ADDENDUM #2

ITB/RFP NUMBER: 2016025-PW-B

Main Street Streetscape Project Phase 3 ITB

DATE: March 8, 2016

**SIGNAL POLE FOUNDATION
INSTALLATION DETAILS**

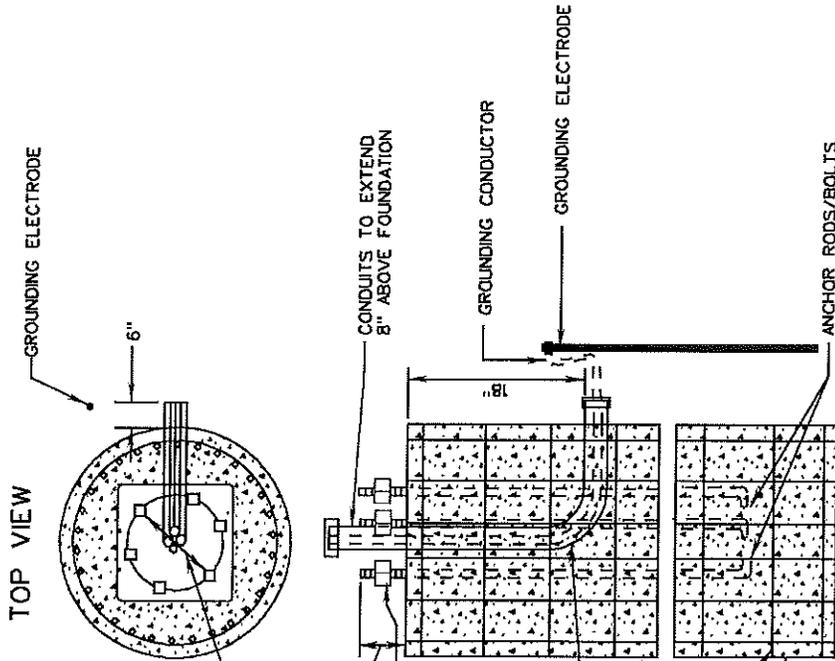
15. Question: The spec on this project indicates an old pole design (PF-1, 6-bolt). The current VDOT spec is (8) 2" minimum. Please advise on whether these are design poles using the new spec with (8) 2" minimum bolts or whether an old pole design is required.

Answer: The pole design shall be the PF-1, 6 bolt design. A detail is attached for reference.
